# CITY OF ALBUQUERQUE

**RE: Raising Cain's C0705**  
**2004 Wyoming Blvd NE**  
**Grading and Drainage Plan**  
**Engineer's Stamp Date: 12/15/2022 (Invalid – Please correct)**  
**Hydrology File: H20D003D**

Based upon the information provided in your submittal received 12/15/2021, the Grading & Drainage Plan is **not** approved for Building Permit, SO-19 Permit, and for action by the DRB on Site Plan for Building Permit. The following comments need to be addressed for approval of the above referenced project:

Raising Cane's - Restaurant # RC 705

C6.0

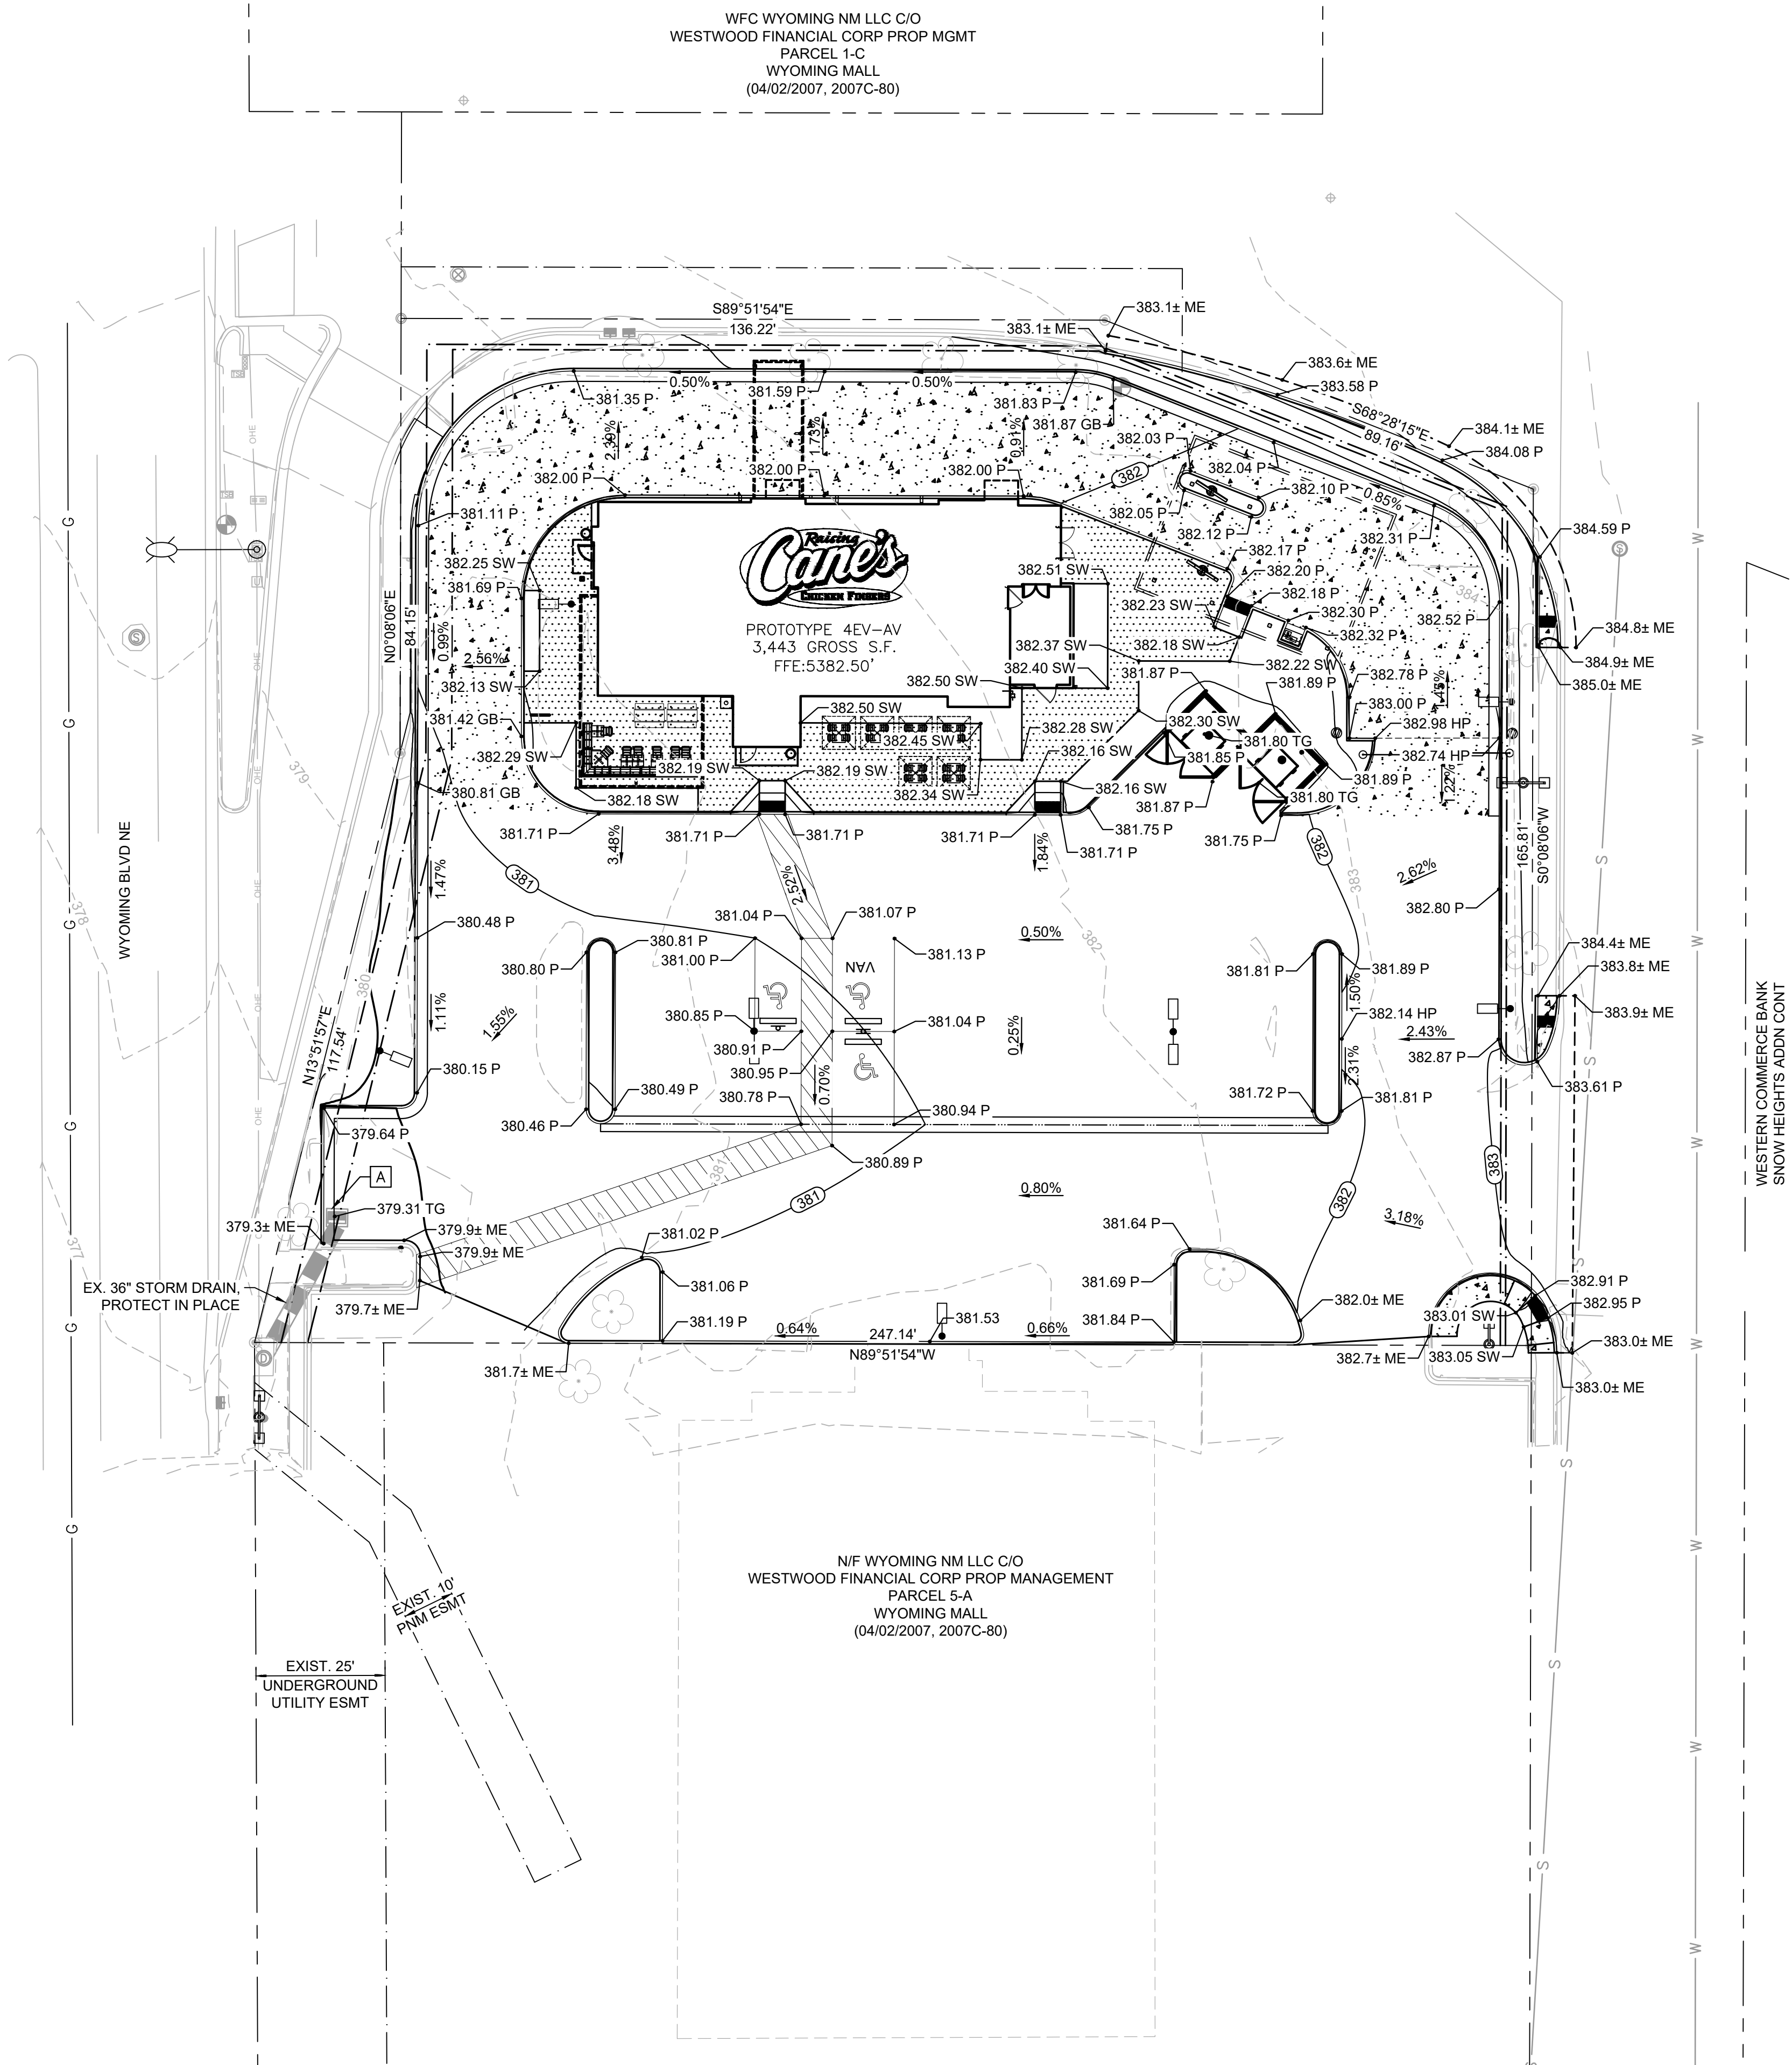
## SHEET C 6.0

1. Please provide containment for trash enclosures per DPM Chapter 6-12(D)(2)
  - a. **Section 6-12(D)(2) Restaurants and Commercial Food Processing** These land uses shall provide a drain in the trash enclosure (i.e. dumpster) pad that drains to the sanitary sewer. On-site stormwater shall not drain onto the trash enclosure pad, and the pad shall be graded to the drain. A berm around the pad may be required to ensure that stormwater runoff from the site will not mix with stormwater falling on the trash enclosure pad.

2. Please see engineer stamp date and revise with new corrected stamp date. It is currently dated 12/15/**2022** and correctly reference the correct year.

3. The legal description notes that there is a lease agreement that shows the Raising Cane's site however the south portion of the lot needs to also be included on the G&D and should include interim grading conditions that will include a silt pond prior to drainage into the public storm system.

4. Please see existing inlets for south portion of the lot. I assume they will be utilized for future plans. Please note to protect in place.

5. Please include the DPM calculations and information on the G&D Sheet to include existing vs. proposed and the narrative summary. Please note existing instead of pre-development as the site is actually developed but is be redeveloped for different use.

6. Provide a Storm Water Quality pond (s) once these calculations have been completed as required per the DPM Chapter 6. Also complete the drainage covenant for the ponds. (attached)

7. For the south portion of the lot, include an interim grading plan that includes a silt pond prior to draining into the existing storm system.
8. Please add a note under Grading Notes. "Side slopes need to be stabilized with Native Grass Seed (per City Spec 1012) with Aggregate Mulch or equal (Must satisfy the "Final Stabilization criteria" CGP 2.2.14.b.)".

9. Please provide the FIRM Map and floodplain note with effective date.
10. Please include project benchmark and datum.
11. Per the DPM Chapter 6, 24"x36" is currently the City's standard. This applies to all site plans, Grading & Drainage Plans, Traffic Circulation Plans, DRC Plans etc. Please resubmit with this plan size.

12. Please provide the SWQV calculations for each basin draining to each pond. The stormwater quality ponds need to be sized for the areas draining to them.
